Flat E, 24 Steele's Road, London, NW3 4RE (2018/1878/P)

Delegated Report	Analysis sheet		Expiry Date:	26/07/2018		
(Members Briefing)	N/A / attached		Consultation Expiry Date:	05/08/2018		
Officer		Application Nu	mber(s)			
Elaine Quigley	2	2018/1878/P				
Application Address		Drawing Numbers				
Flat E 24 Steele's Road London NW3 4RE		See draft decisior	n notice			
Proposal(s) Installation of front and rear dormer window in association with the creation of additional habitable accommodation in the roof.						
Recommendation(s): Grant conditional planning permission						
Application Type: Full Plar	Full Planning Permission

Installation of front and rear dormer window in association with the creation of additional habitable accommodation in the roof.

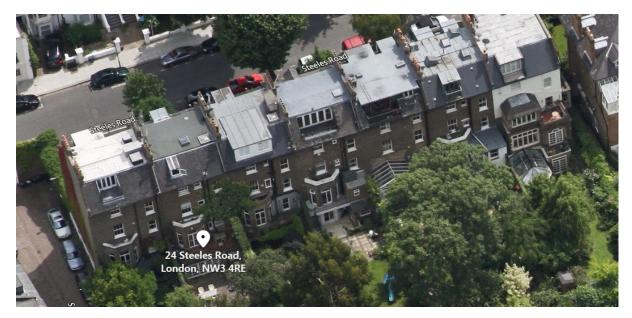
- 2.2 The original drawings also included the removal of the existing dormer window in the rear elevation and replacement with a larger dormer window. The rear dormer window was considered to be architecturally unsympathetic to the host building in terms of its size, fenestration and its close proximity to the existing chimney breast. In response to officer's concerns, the applicant revised the proposal to reduce the width of the rear dormer window, change the fenestration to be more reflective of the existing fenestration below and to position it away from the chimney breast. The table below includes the changes:

3.7 The rear dormer window would include two window openings and would be set away from the parapet walls by 0.42m and 1.04m. It would not be set down from the ridge of the roof by 0.5m but would be similar in its position to the existing dormer window. It was apparent from on-site assessment that the rear roof slopes along this side of the terrace have been altered in a number of ways. Those at nos. 23 (approved in 1999) and 26 have inset balconies, no. 25 and 27 have dormer windows that extend up to the ridge and extend across over half the width of the roofslope. It is acknowledged that none of the rear dormers were approved after the adoption of the CAS but they are now part of the established character of the roofscape of this part of the terrace. Given this context and the limited visibility of the rear roof slope from public vantage points, the proposed changes are considered to be acceptable.

Dormers	Height (m)	Width (m)	Depth (m)				
Front dormer							
Existing	1.14	0.9m	0.81				
Original proposal	0.67	1.87	0.81				
Revised proposal	0.67	1.57	0.81				
Rear dormer							
Existing	0.7	0.6	0.81				
Original proposal	0.7	2.58	0.81				
Revised proposal	0.7	2.34	0.81				
Revised proposal	0.7	2.34	0.81
